Supplement Sheet

Subject: Torque Bracket Rework

PURPOSE: This supplement sheet provides the rework instructions, if required see below, for the side-to-side cross member torque bracket when replacing the **618-04034** transmission with the service replacement **618-04566** supplied in the **753-05851** service kit. No rework of the torque bracket is required if the torque bracket is of the cantilever style (see Figure 2).

FIGURE 1

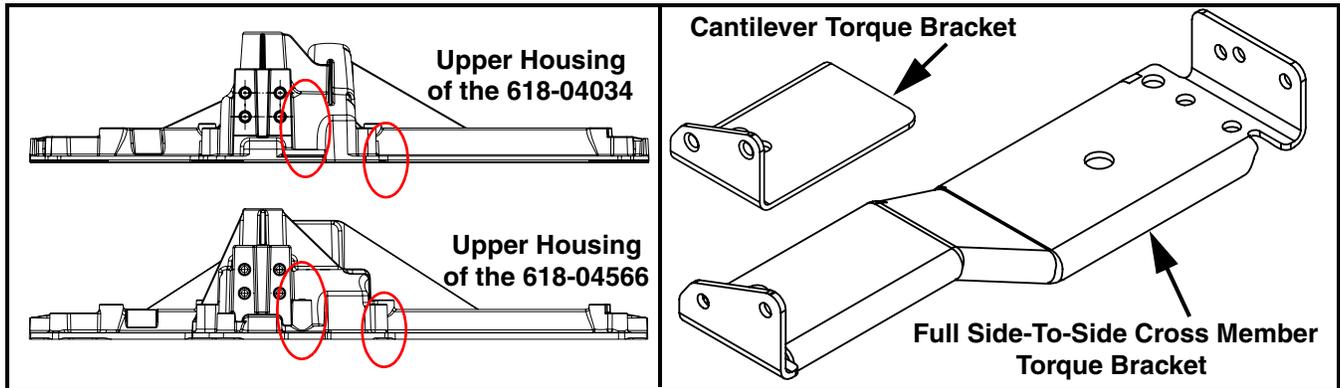
The configuration of the upper housing of the new 618-04566 transmission (See Figure 1) will interfere with the cross member torque bracket at two points. This results in the transmission not seating onto the frame at it's mounting points.

1. Lawn tractor is a 600 Series AutoDrive, Transmatic or Shift-On-the-Go (non-hydrostatic transmissions) model
2. The existing transmission, being replaced, is a single speed 618-04034. See area of concern in Figure 1.
3. The existing torque bracket is a full side-to-side cross member style as shown in Figure 2.

FIGURE 3

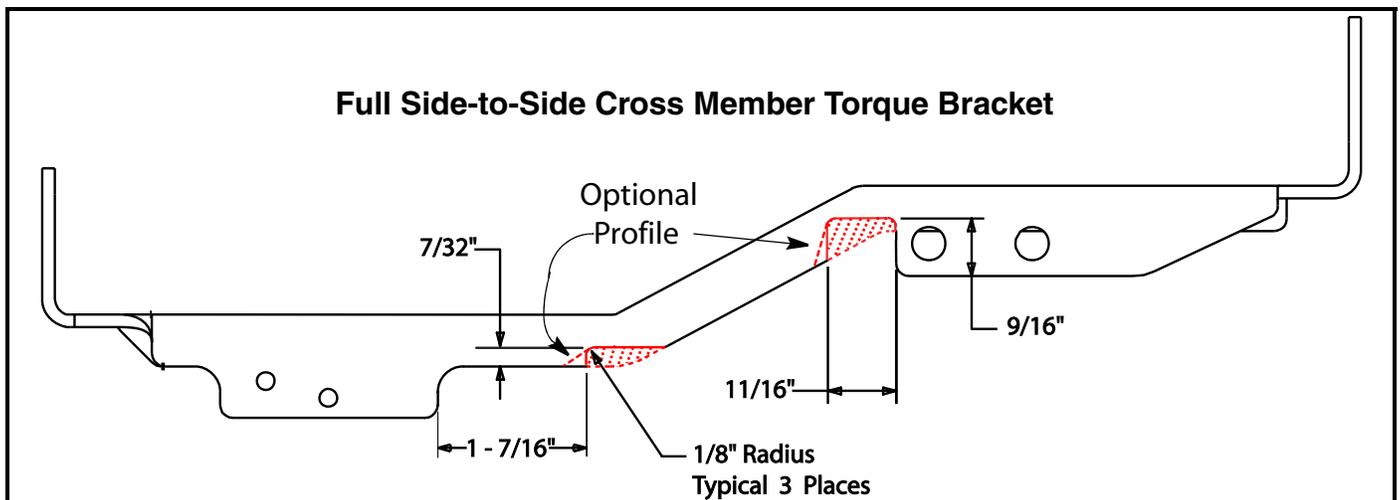
1. With the transmission removed from the lawn tractor, mark the cross member as shown in red in Figure 3.

2. Using a 4-1/2" hand held angle grinder with a 4" abrasive cutoff disk, remove the torque bracket material shown in red in Figure 3. Remove the material slowly so as not to over heat the part.
3. Remove any burrs or sharp edges with a file. Use a primer/sealer to cover the exposed metal.
